SERVICE BULLETIN

Bulletin No. 75-29
Date August 22, 1975
Page 1 of 2

SUBJECT: SPARK PLUG CAP
Affected Models: GT380M and GT550M
Effective Engine No.: E NO. GT380-36035, GT550-60143
Reference: _____

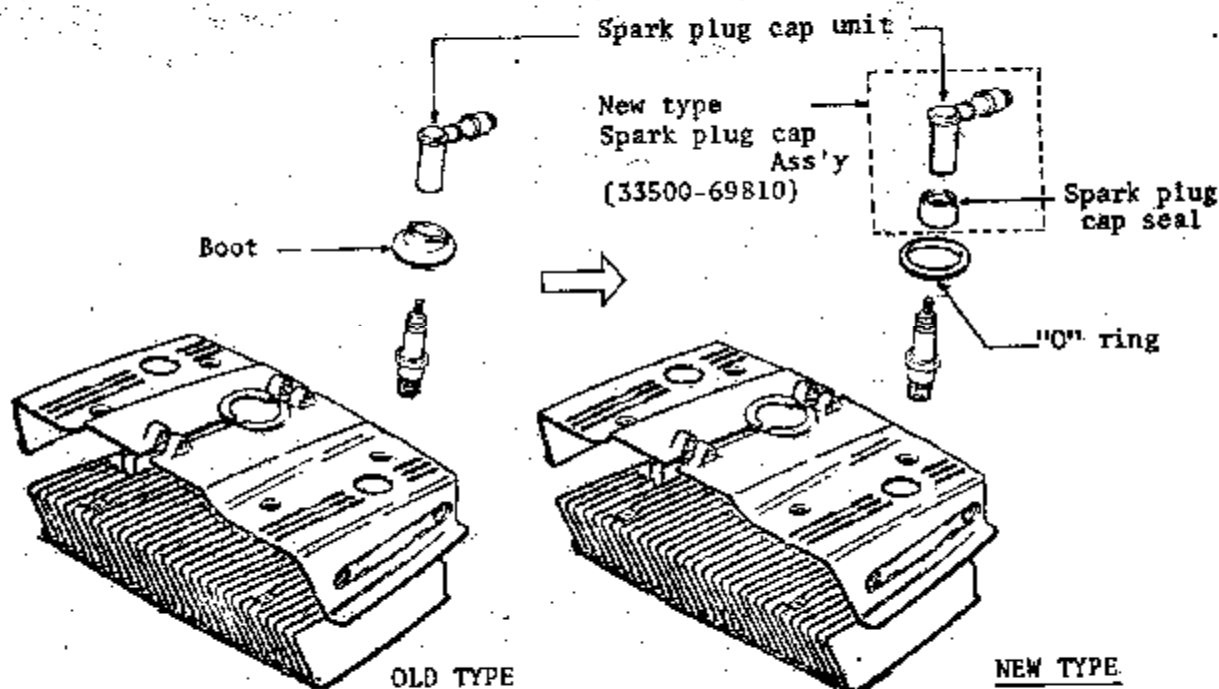
This bulletin is intended to inform you that the spark plug cap sealing has been modified into a conventional type in order to prevent a high tension leak from the spark plug cap.

In this modification, the spark plug boot has been removed and an "O" ring has been fixed to the cylinder head cover. No modification has been carried out in the cap unit itself.

Caution: In case of any engine trouble due to leakage of electricity from the spark plug cap (mis-firing of the engine), the plug cap should be changed to the new type and at the same time an "O" ring should be fixed to the cylinder head cover.

Spark plug cap Ass'y
(33500-69810)

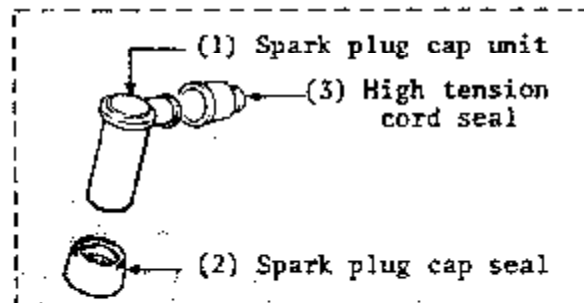
Note: In addition to the supply of the spark plug cap unit as before, the new type assembly will be supplied too. The diagram below shows the components of the new type.

- (1) Spark plug cap unit (33510-22010)
- (2) Spark plug cap seal (33541-69010)
- (3) High tension cord seal (33542-98000)
